## SERVICE BULLETIN

HEATING AND  
AIR CONDITIONING  
REFERENCE \_\_\_\_\_  
NUMBER 008  
DATE 07-08-88  
MODEL AW (MR-2)

### ANTI-CORROSION PERFORMANCE OF HEATER PIPES

HEATER WATER PIPE

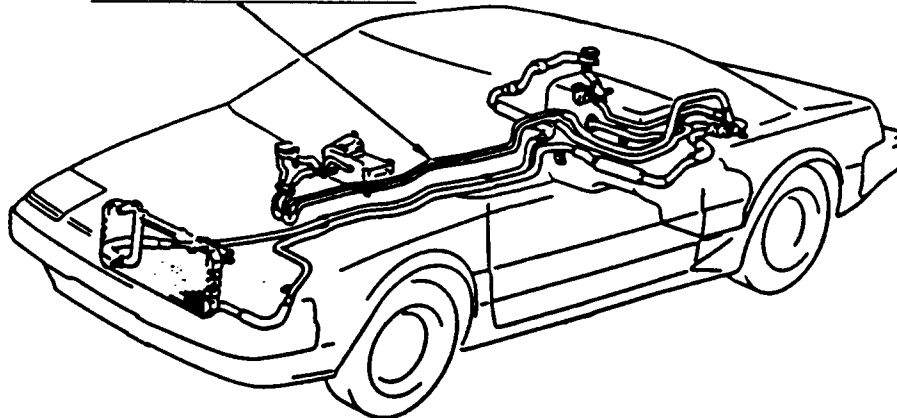
The material of the heater water pipe sub-assembly on AW models has been changed to improve corrosion resistance.

PREVIOUS: ZINC-PLATED STEEL  
IMPROVED: BRASS

Part Name	Prev. P/N	New P/N
Pipe sub-assy Heater Water Pipe <b>A</b>	87208-17030	87208-17031
